Service Letter No. 212

Subject: Nose Wheel Shimmy Dampener, Part No. 13086-00

Models Affected: All 1953 Model PA-22's with serial numbers 22-807 to 22-1614 inclusive, 22-1616 to 22-1631 inclusive, 22-1633 to 22-1635 inclusive, 22-1638, 22-1642, 22-1646 to 22-1648 inclusive, 22-1651, 22-1653, 22-1655, 22-1656, 22-1658 to 22-1661 inclusive, 22-1666, 23-1667, 22-1672, 22-1678, 22-1680, 22-1682 and 22-1683.

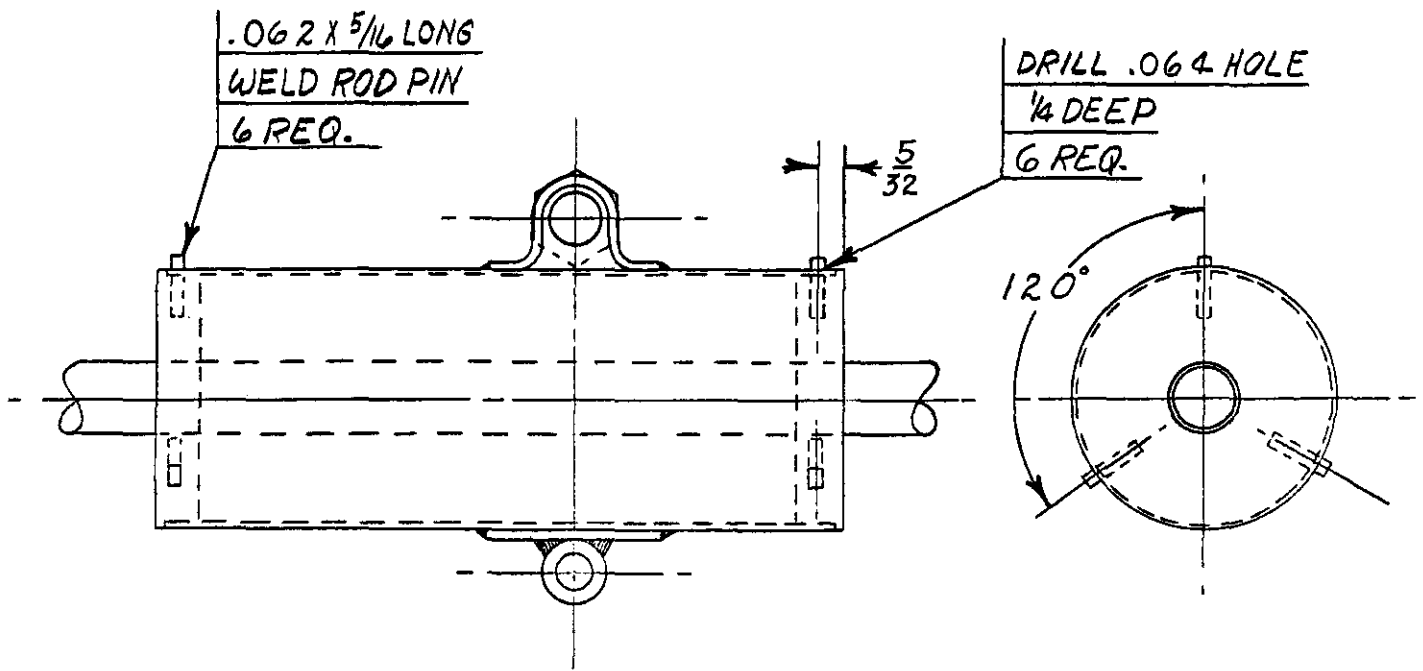
During the past few months we have received from the field a number of shimmy dampeners, part number 13086-00, on which a separation has occurred between the assembly body and the end plate. This separation was due to solder breaking loose and the internal fluid pressure plus the friction of the plunger forcing the end plate outward.

All production airplanes have been modified in accordance with the sketch shown on the reverse side of this Letter and it is felt that this modification can be satisfactorily executed in the field as a service-fix. Upon inspection if the shimmy dampener shows signs of separation, it will be exchanged free-of-charge at the nearest Piper Distributor or Dealer.

DRIVE PIN INTO EACH HOLE AND SOLDER END, COVERING  
PIN WITH SOLDER.
